DATE: June 5, 2019

AGENDA ITEM # 2

TO: Design Review Commission
FROM: Steve Golden, Senior Planner
SUBJECT: 18-SC-04 – 446 South Clark Avenue

P-1 (above) Redwood trees to be impacted by construction project - shot from South Clark, looking over the existing roof of 446 South Clark Avenue.

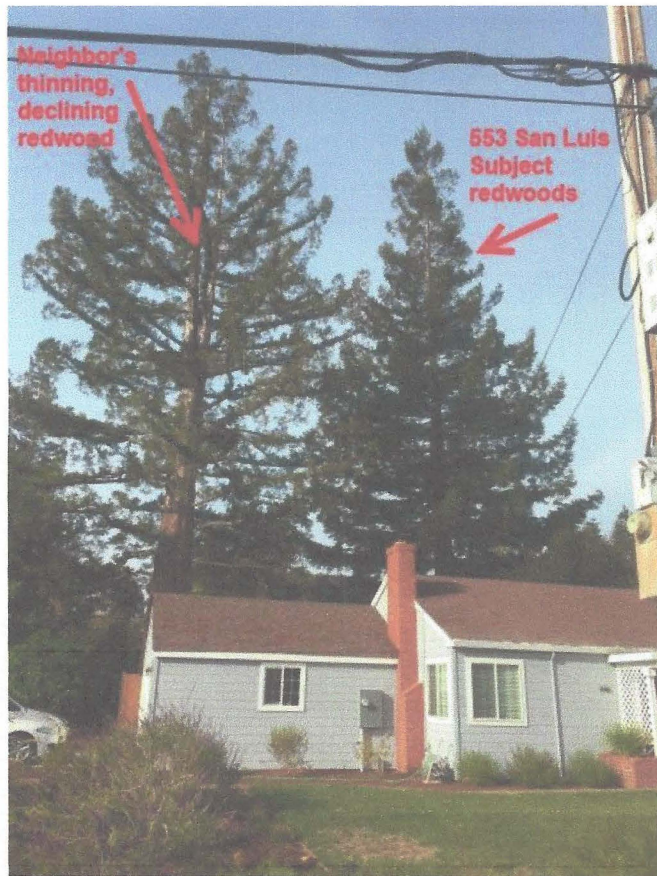
2.1 I met Maureen & John Stuart on site December 2 when I interviewed them to learn about their redwood trees, the project planned for next door, and the Kielty arborist report written from the perspective of the adjacent project. I then continued taking my own notes and to develop my independent opinion.

P-1 (above) (taken by me on December 2, 2017) Redwood trees impacted by construction project - shot from South Clark, looking over the existing roof of 446 South Clark Avenue.

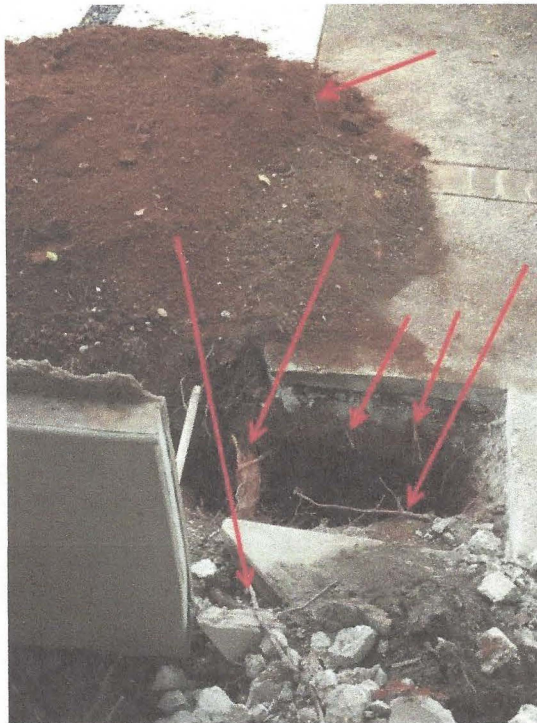
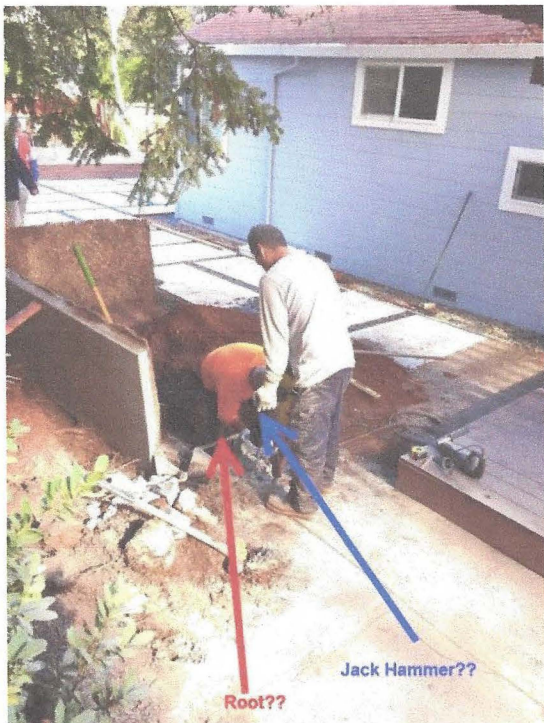
I spoke on the telephone and received email messages from Maureen on January 19. The emails contained JPEG copies of some of the photographs she had taken of the work in progress in the redwood trees' root zone.

I have included the most relevant images as P-2, P-3, P-4, and P-5 below.
